SUBJECT: FORWARDING MEETING SUMMARY DATED JANUARY 27, 1993

Enclosed is the summary of a meeting held between the staff and GE on January 11 through 21, 1993, to discuss inspections, tests, analyses, and acceptance criteria.

Enclosure:
Meeting Summary
dtd 01/27/93

NUCLEAR BOILER SYSTEM

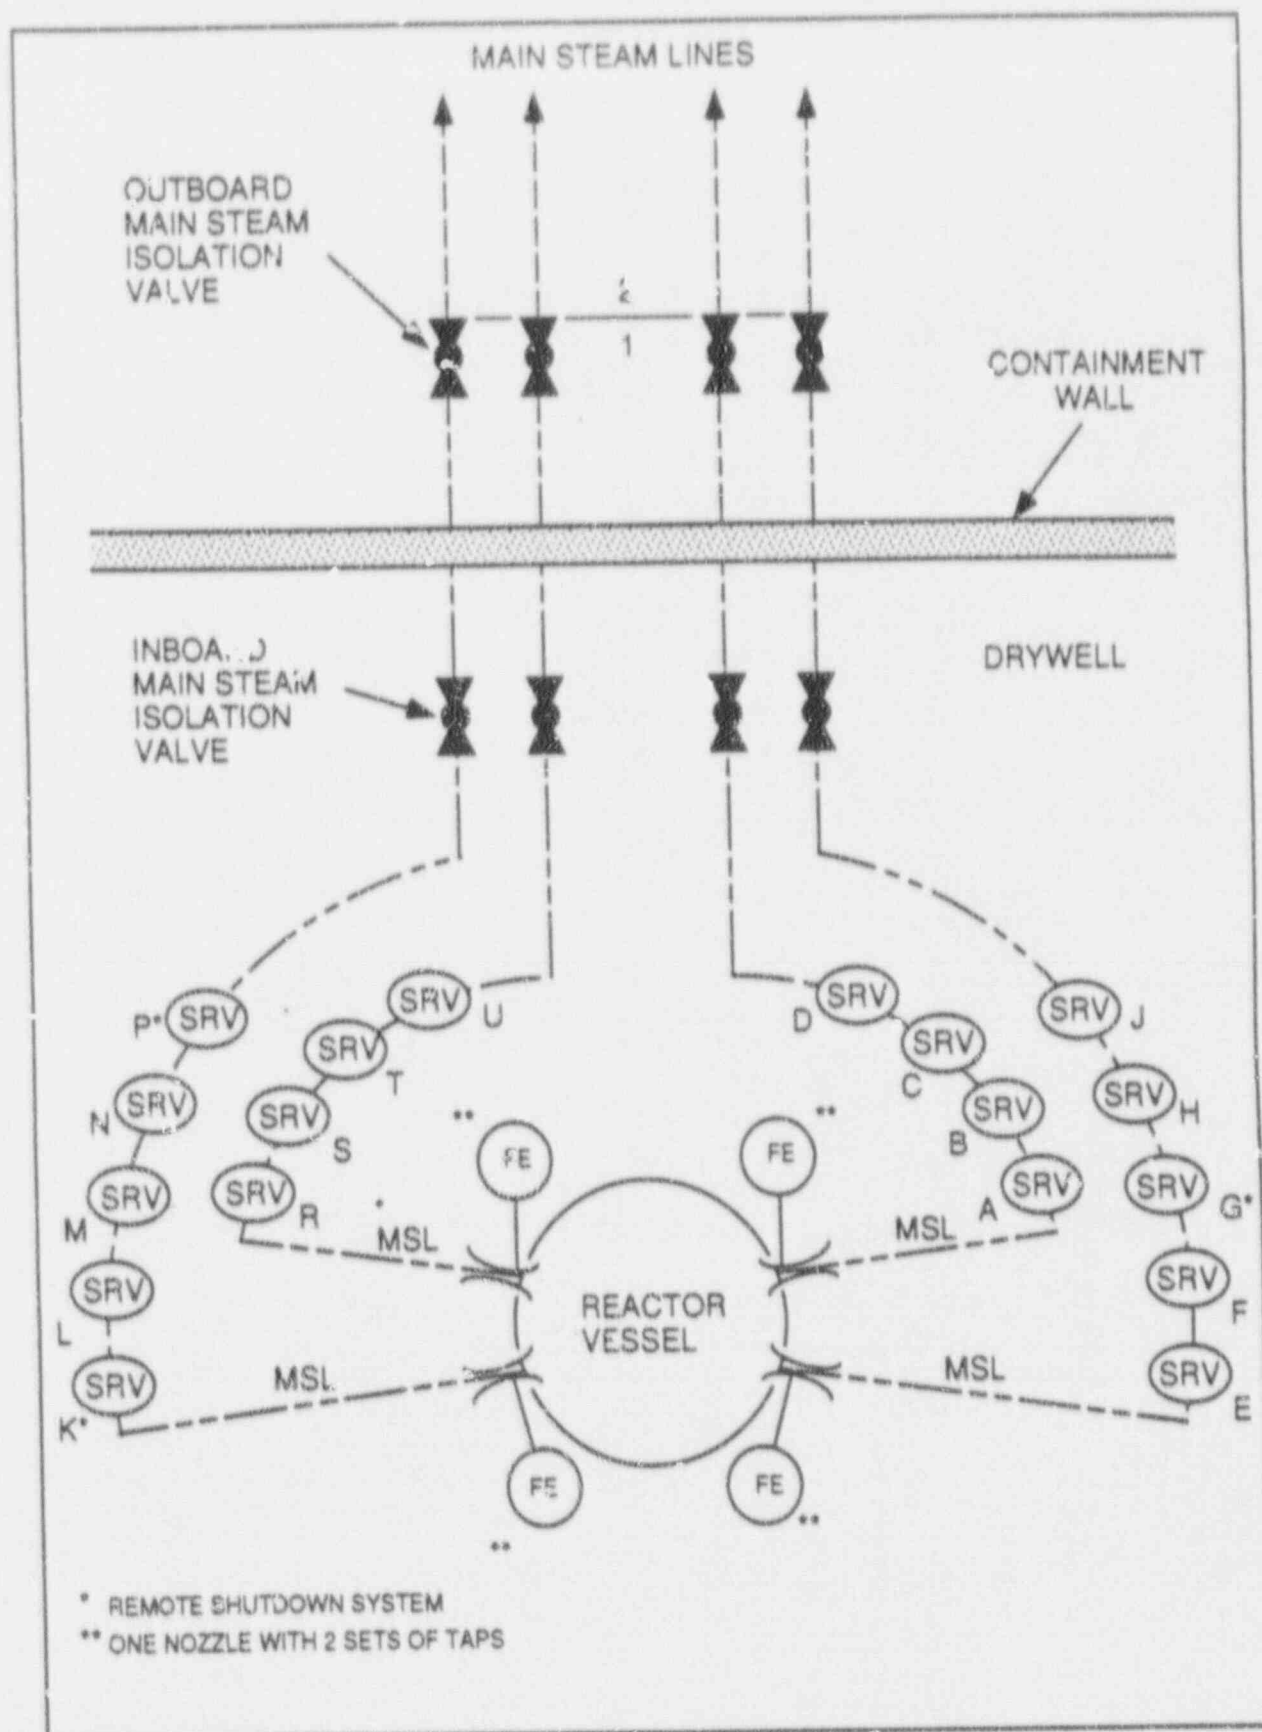
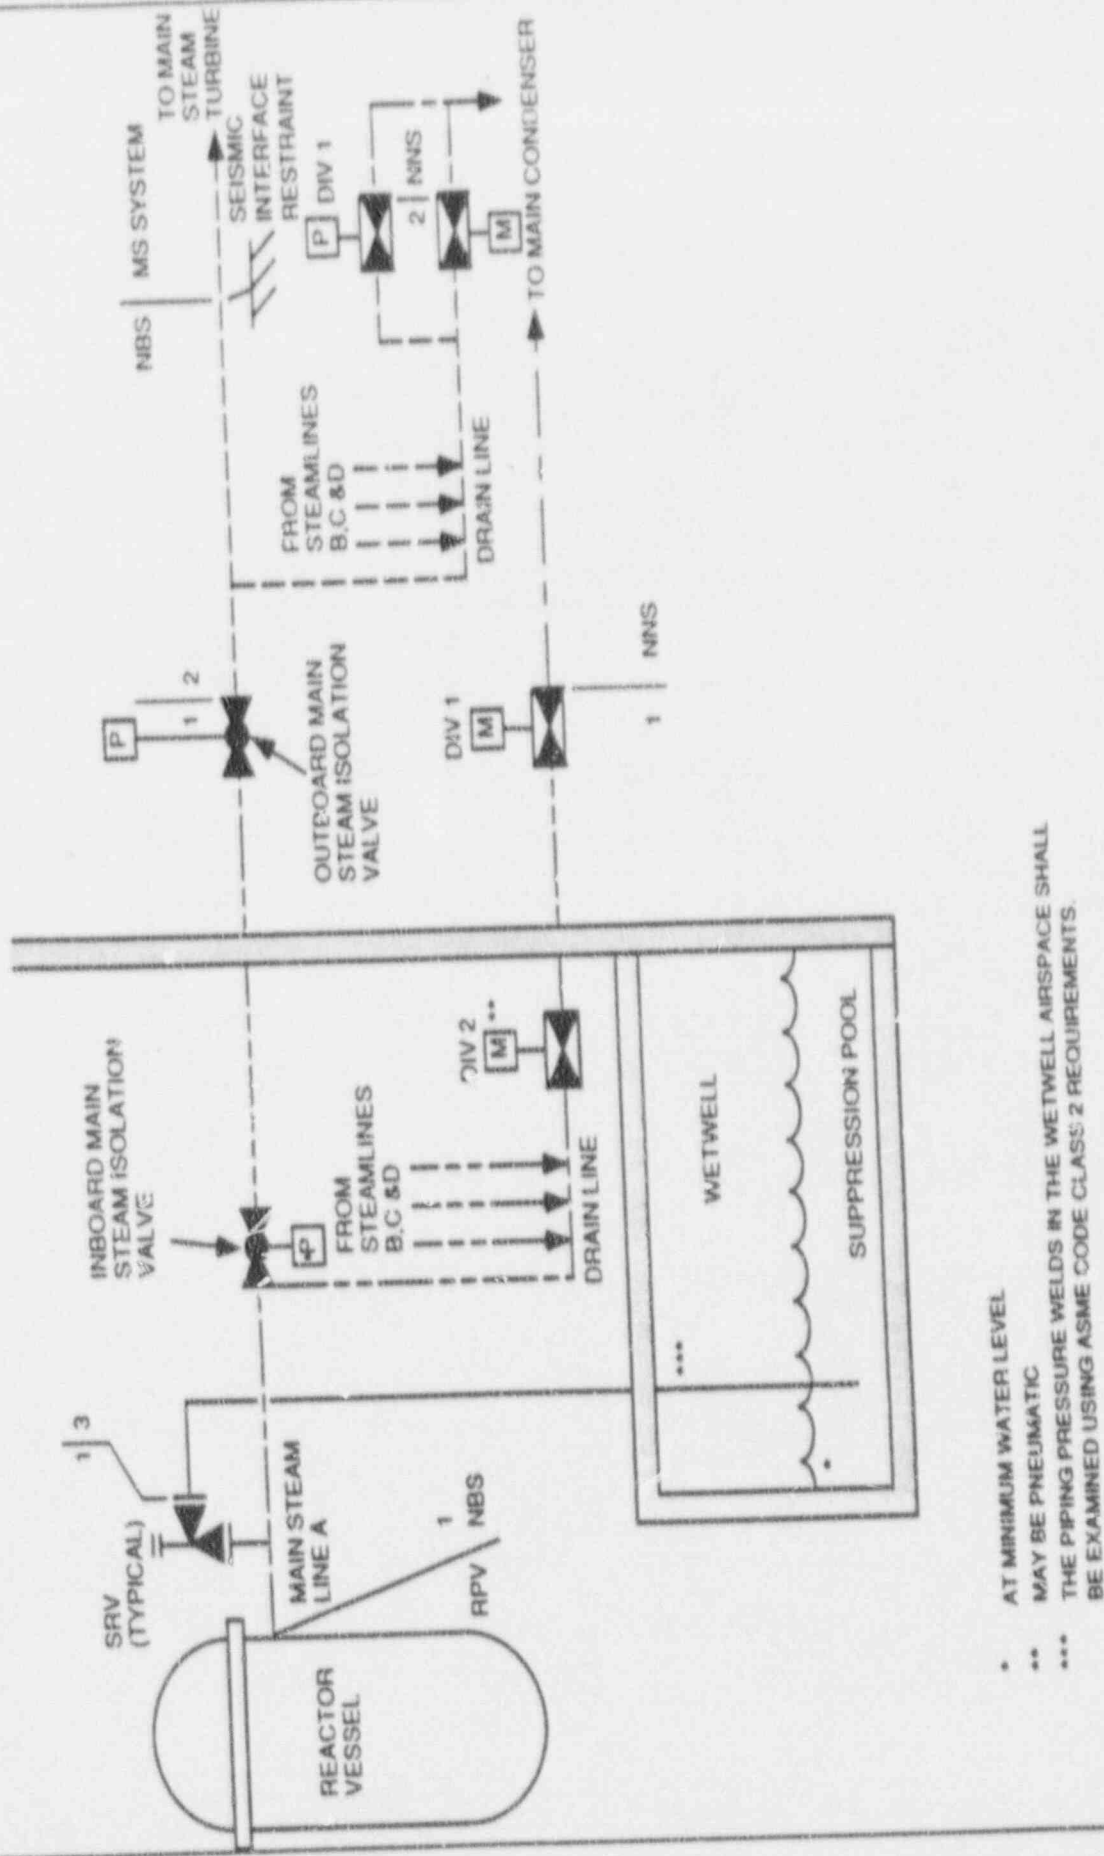
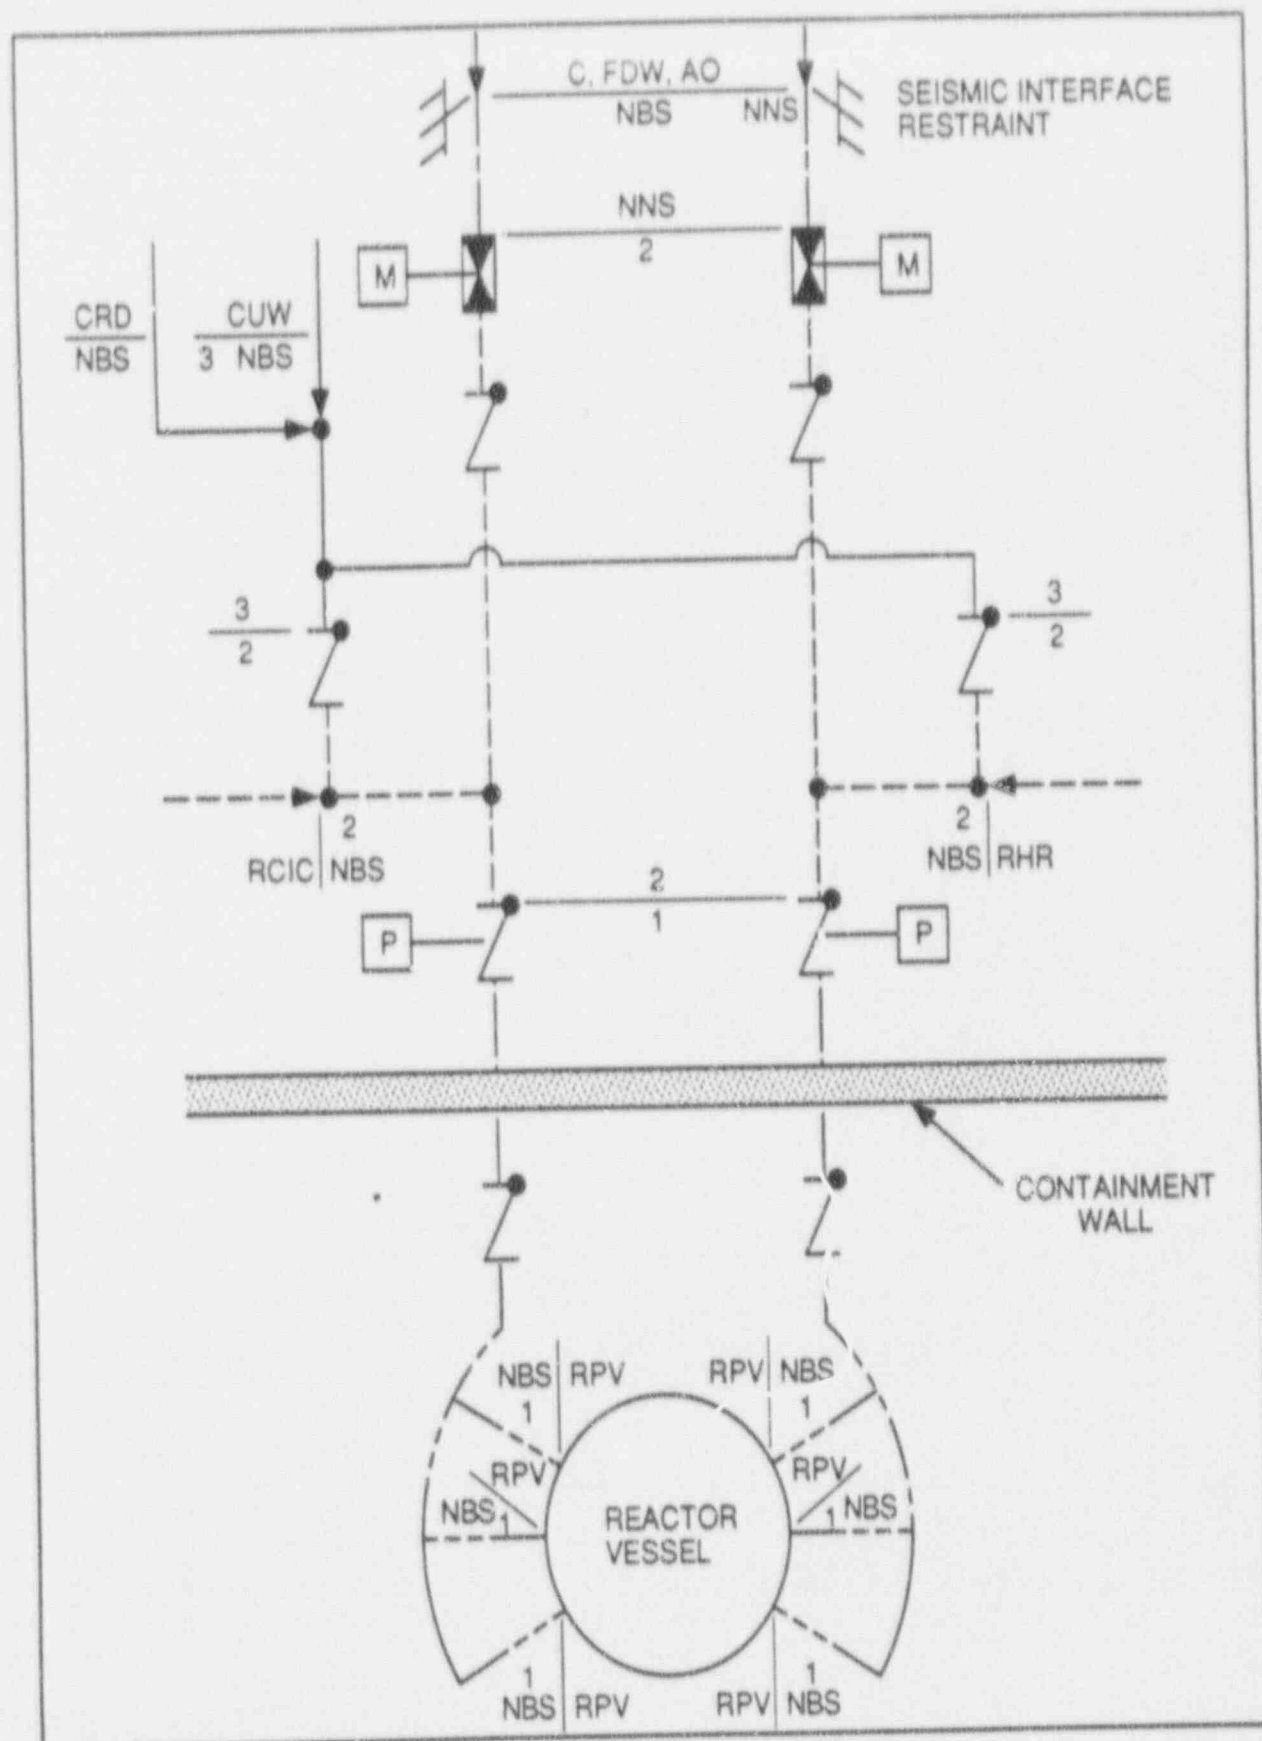
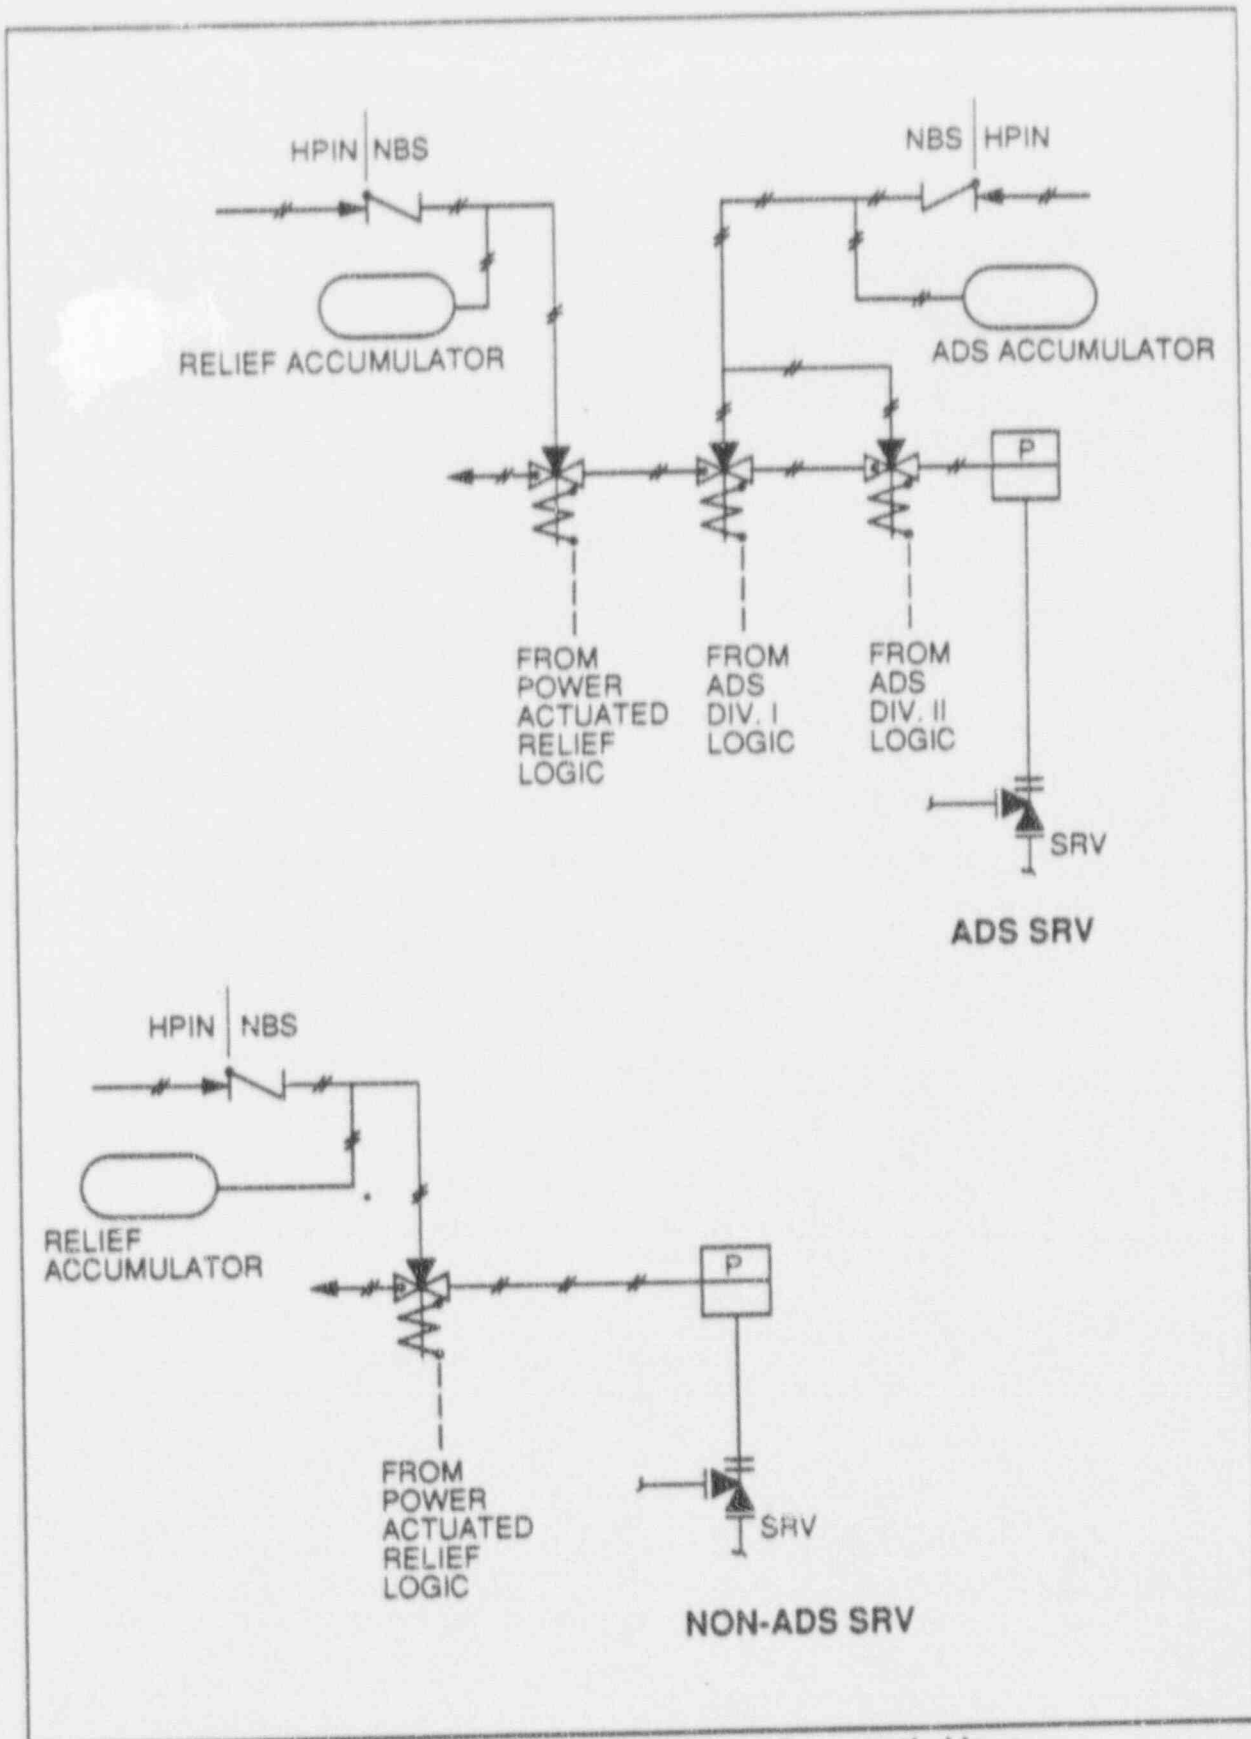
- Ⓐ NEED TO REFERENCE FIGURE / p3 2.1.2 D AND INCLUDE IT.
- Ⓑ INSERT BOILER PLATE AND / OR ITAAC TO ADDRESS BWR PRESSURE VESSEL LEVEL PROBLEM.
- Ⓒ ADD STD. BOILER PLATE AS SHOWN BY JOHN CHAMBERS (CAPTURE SPECIFIC TIMES FOR TIMERS)
- Ⓓ ANALYSIS ALGORITHM TO BE PROVIDED IN TIER 2
- Ⓔ ADD BOILER PLATE ✓
- ~~Ⓕ IDENTIFY EXCEPTIONS TO PHYSICAL SEPERATION~~
- Ⓖ STD. ELECTRICAL / I+C SEPERATION ITAAC
- Ⓖ CHECK MAIN CONDENSER DESIGN DESCRIPTION FOR INLET PRESSURE AND CONDENSER VACUUM
